ARCHITECTS COMMENTS

TITLE		DRAWING NO	
Astor House - Blue Roof Detail		ECO-00008-001	
Scale	Drawn by	Date	
NTS	J G	07/09/17	
Unless otherwise specified dimensions are in millimeters angles ± 2° decimal dimensions ± 2mm			
Revision		Date	
D		17/01/18	
B		17/11/17	
C		22/11/17	
Revision		Date	
A3

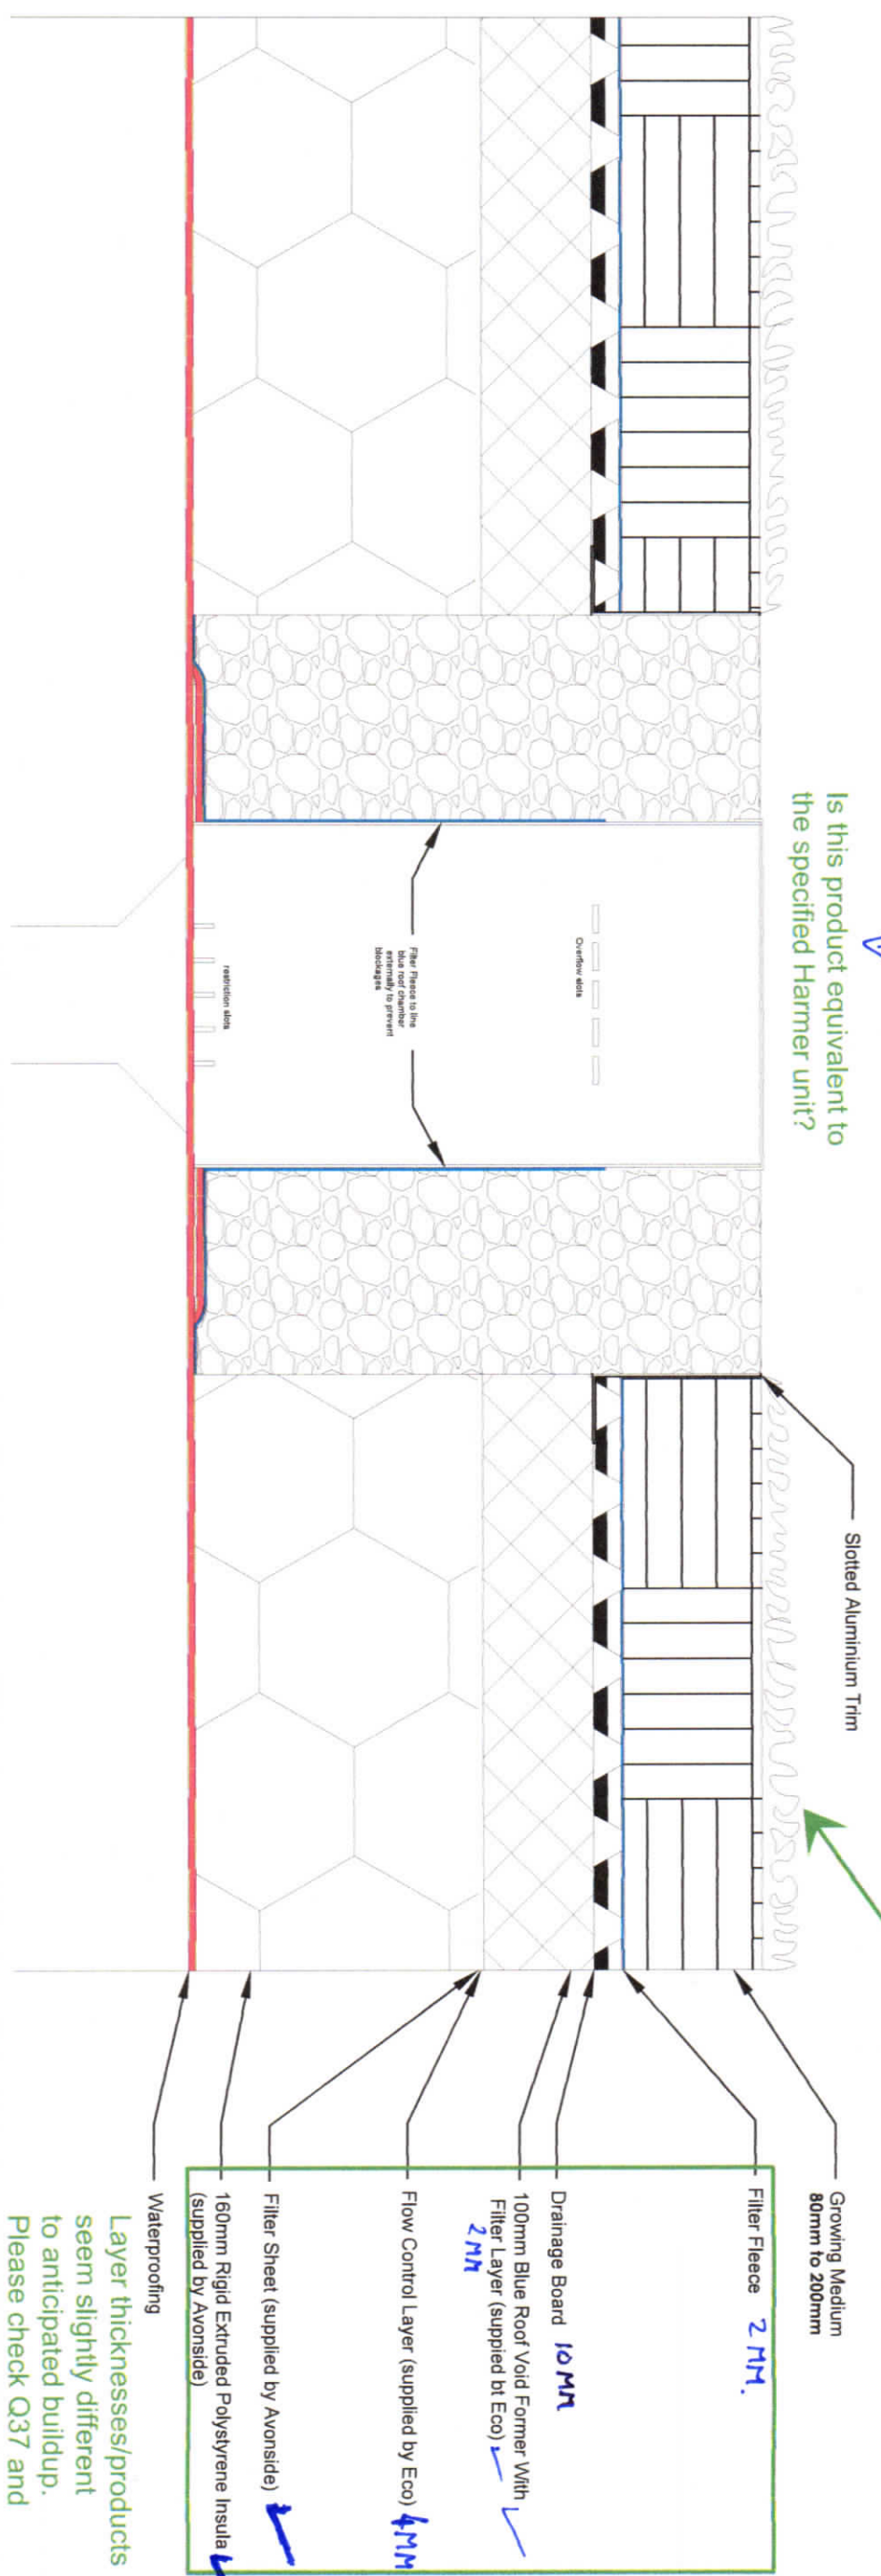
Is this product equivalent to the specified Harmer unit?

What vegetation is proposed? Ensure that it meets spec.

Layer thicknesses/products seem slightly different to anticipated build up. Please check Q37 and ensure that all requirements are met.

- OUTLETS INSTALLED BY OTHERS.
 - THESE ARE RESTRICTORS.
